## Bid Addendum No. 5

December 7, 2023

### Pawling Central School District 2020 Capital Project – Phase 3

CSArch Project No. 208-2101.03

PES  
AD201

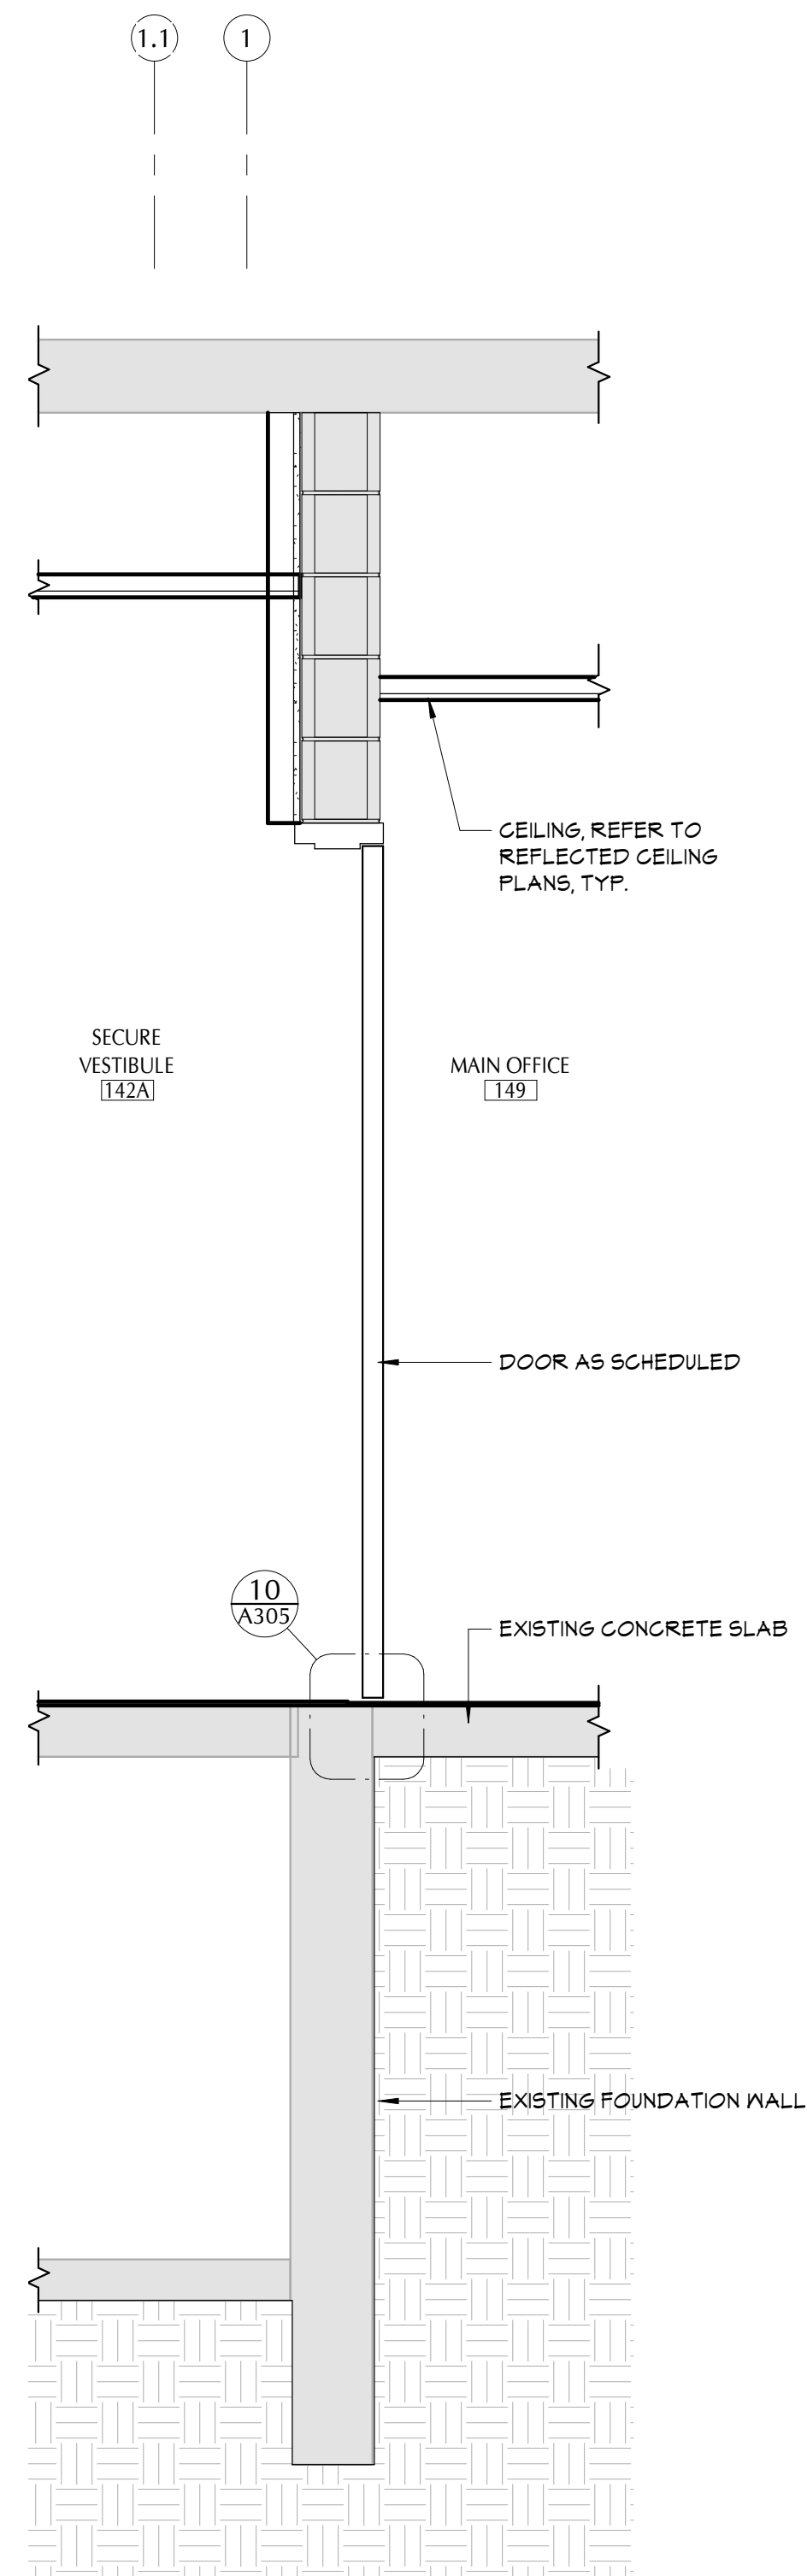
12. **Delete** drawing sheet AD201, **Add** revised drawing sheet AD201.
13. Drawing A201, A202, A203:  
**Add** note "THE B1, B2, B3, B4, B5 KEY NOTES ARE BASE BID WORK SCOPE."
